HISTORIC PRESERVATION COMMISSION STAFF REPORT

Address:	7300 Cedar Ave., Takoma Park	Meeting Date:	3/28/18
Resource:	Outstanding Resource Takoma Park Historic District	Report Date:	3/14/18
Review:	HAWP	Public Notice:	3/7/18
Case Number:	37/03-18M	Tax Credit:	None
Applicant:	John Lorenz & Christine Simpson	Staff:	Dan Bruechert
Proposal:	Hardscape Alteration

PROPOSAL

The applicant proposes to replace the existing fieldstone patio with a new patio, fireplace, privacy screening, and natural stone steps.

Figure 1: Proposed lattice (pen shown for scale).

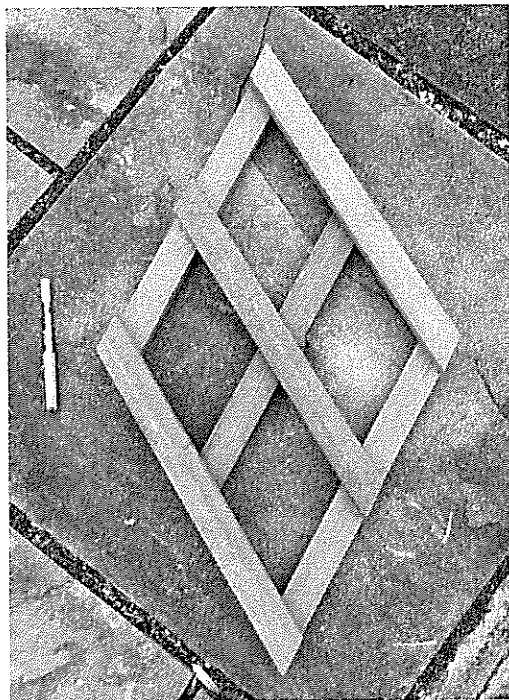
The applicant further proposes to install a pergola to either side of the fireplace. These will be wood structures, with wood columns and will stand approximately 7'6" (seven feet, six inches) tall. The current design proposal calls for the installation of a section of lattice inset to the pergola to provide privacy screening. Staff finds that the materials are consistent with the house and surrounding district. The proposed lattice will have large diamond-shaped openings that are 8" x 6" (eight inches by six inches).

Staff's initial reaction to the proposal was that the proposed chimney and pergola were too tall and too opaque and would make a 'wall' between the street and the house; and that this would contravene the *Guideline* stating that changes should respect the patterns of open space within the district. However, after conducting a site visit and meeting with the applicant, Staff supports approval of this element for two primary reasons. First, the applicant provided Staff with specifications for the lattice to be installed within the pergolas. A standard lattice has an approximately 2" (two inch) square opening that would create an almost opaque appearance when viewed from 20' (twenty feet) away. The applicants' proposed lattice has significantly larger openings that would allow for visibility through the lattice. The 8" x 6" (eight inch by six inch) openings will allow for much more visibility while still providing some additional screening. Second, this house sits at the northwest edge of the Takoma Park Historic District.

Staff finds that this proposal is acceptable in this specific location because of its unique siting at the boundary of the historic district. Staff would not recommend approval of a similar proposal elsewhere in the district due to its high visibility and its impact on the environmental setting and patterns of open space. Staff recommends approval.

Figure 2: Map showing the boundaries of the Takoma Park Historic District

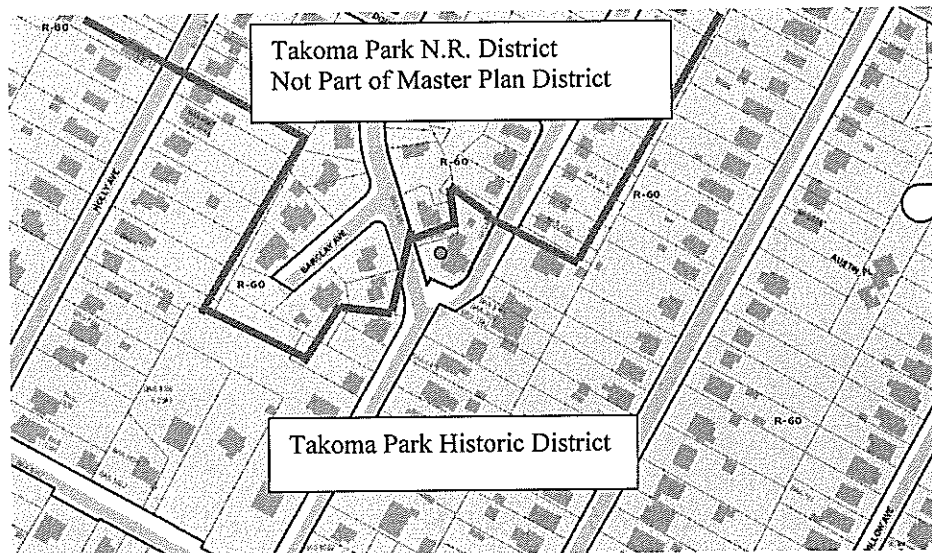
The angles where the chimney and lattice would have the largest visual impact on the historic house are outside of the district, and the HPC should give this view much less weight than views from within the historic district. The potential views of these elements from within the historic district are largely from on the property itself. The proposed placement of the lattice and chimney will not impact the view from this historic property to the rest of the historic district.
